PRODUCT CHANGE**Change:** New battery set for perma STAR VARIO**PCN-No.:** 1211-02-01**Date:** 05 November 2012**Description of Change:**

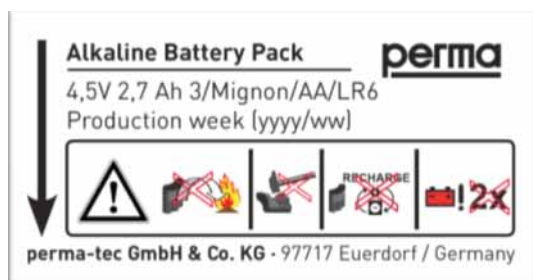
Battery set for perma STAR VARIO was improved.
Battery label with new design.

The new battery set consists of two covers (for both poles). Both covers are soldered together and protect battery connectors. The battery set is placed into perma STAR VARIO just like the old version (in direction of the arrow). Placement does not require any additional steps during battery exchange. Existing operating instructions remain valid.
